SUBJECT: NUCLEAR REGULATORY COMMISSION INSPECTION REPORT  
NO. 99901473/2016-201 AND NOTICE OF NONCONFORMANCE

**U.S. NUCLEAR REGULATORY COMMISSION  
OFFICE OF NEW REACTORS  
DIVISION OF CONSTRUCTION INSPECTION AND OPERATIONAL PROGRAMS  
VENDOR INSPECTION REPORT**

Report No.: 99901473/2016-201

Vendor: General Atomics Electromagnetic Systems Group  
10880 Thornmint Road  
San Diego, CA 92127

Figure -1 Typical Source Range

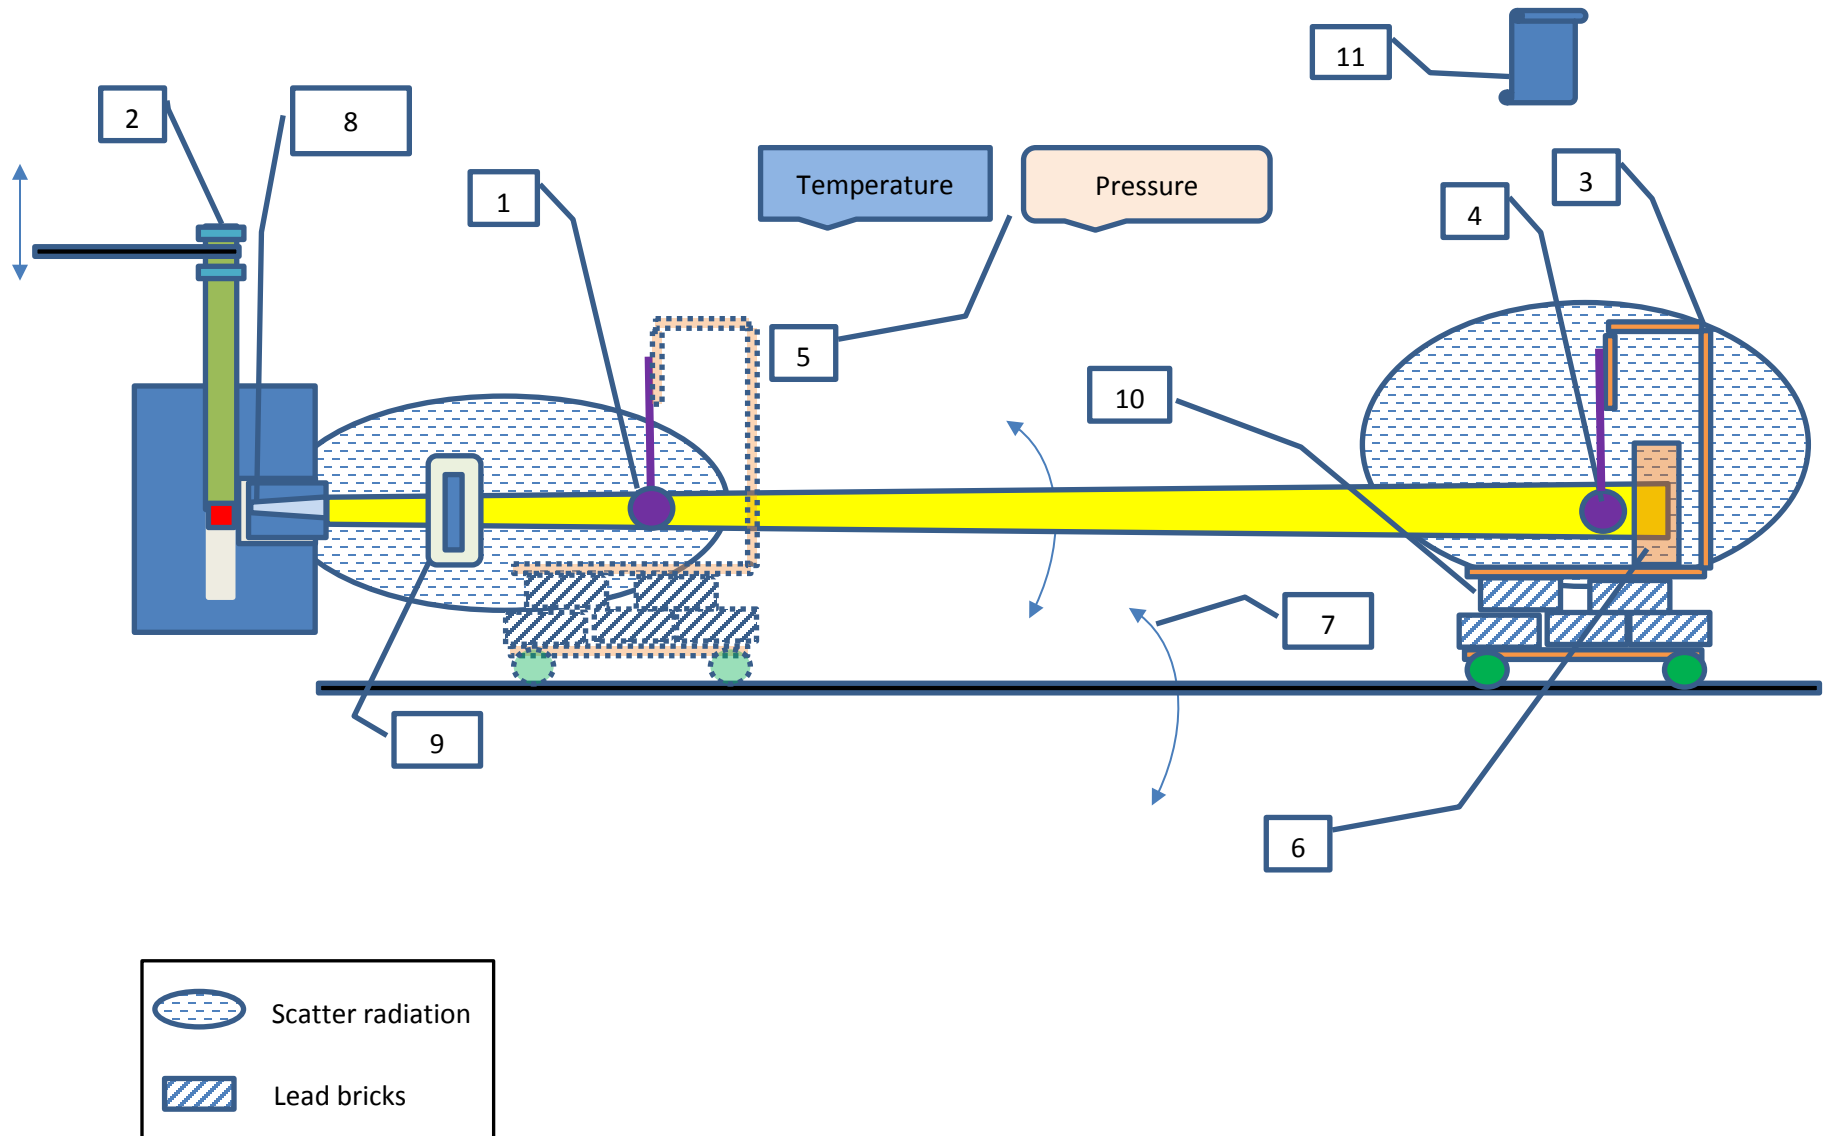
could result in a lower than expected delivered dose rate and add to the uncertainty of the calibration process (refer to item 9 of Figure-1 in the Attachment). The NRC inspection team identified this as the third example of Nonconformance 99901473/2016-201-03 for GA-EMS's failure to establish sufficient controls on the configuration of a Cs-137 source assembly to assure a repeatable geometry and radiation field for calibrations of the Cs-137 source and RMS detectors. GA-EMS issued iCAR QN No. 7017028 on this issue and stopped use of the Cs-137 source for calibration until the effect on calibration could be determined.

6. Potential Inaccuracies in Source Assembly (refer to Figure-1 below)

- (2) GA-EMS drawings did not specify the position of Cs-137 source in the source exposure port or verify that the source was centered. If the source is off center, the orientation of the radiation beam may not be horizontal, thus adding to the uncertainty of the calibration of the RMS detectors.

- (3) GA-EMS did not have measures to prevent movement of the bracket used to hold the CalV detector, which could potentially add to the uncertainty of calibration of the Cs-137 source.

- (5) GA-EMS did not ensure that M&TE used by CalV to measure pressure and temperature, which is used by CalV to correct the output of the vented ion chamber used for the calibration of the Cs-137 source, was properly calibrated. This could reduce the accuracy and increase the uncertainty of the calibration of the Cs-137 source.

- (8) GA-EMS did not adequately control the configuration of the attenuators used for the Cs-137 source assembly. The configuration of the attenuators affects the amount of scatter radiation from the source shield and the attenuators which can change the energy spectrum near the source. This may invalidate the use of inverse-square as a method of estimating the exposure rate.

- (10) GA-EMS changed the configuration of lead material without documenting or evaluating the effects of the change on the amount of scatter radiation in the area. Changing the material in the vicinity of the detector can cause scatter that effects the radiation readings.

- (11) GA-EMS did not account for the uncertainty provided by CalV to the total accuracy and uncertainty stated by GA-EMS to their customers for the RMS detectors.
